IN THE MATTER of Private Plan Change 41

Report on submissions relating to Plan Change 41

**D & S Anderson request to amend the rezoning
Rural (Inner Plains) zone land to Living 3 zone at
311 Trents Road, Prebbleton**

FENCING TYPOLOGIES – LIVING 3 ZONE

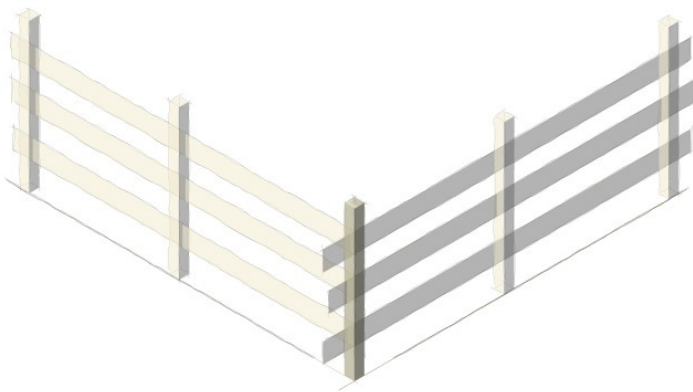
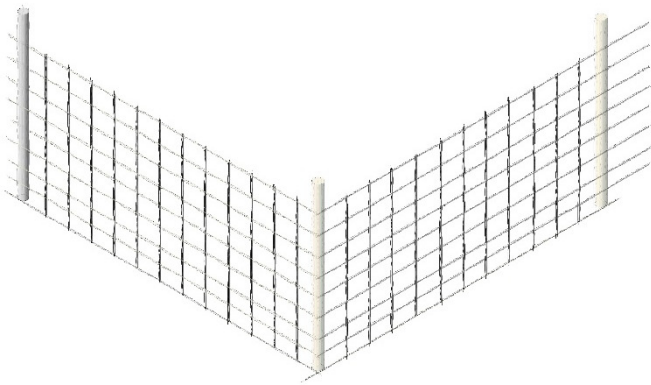
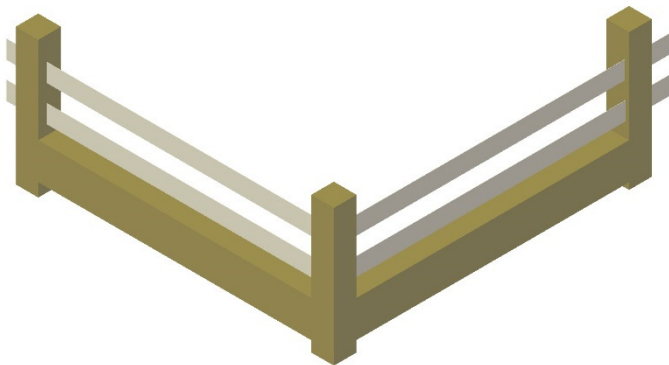
- 6.46 **Fencing (C-4.2.3 and Appendix 43):** Accept the wording proposed in PC 41 and accept the fencing typologies set out in (what is now) Appendix 43 (refer Attachment F). The wording proposed in PC 41 will replace the operative wording of this rule that is complex and ambiguous. The wording proposed in PC 41 will apply to all Living 3 zones, however the proposed rule is considered to be easier to understand and administer and more effective in delivering the open, visually permeable fencing outcomes sought in the RRS14 across the Living 3 zones than the operative provision.

- **The extent to which native species are used as street tree plantings and within vegetated stormwater swales;**
 - **Whether street trees are proposed with regard to the cross-section shown in Appendix 43.**
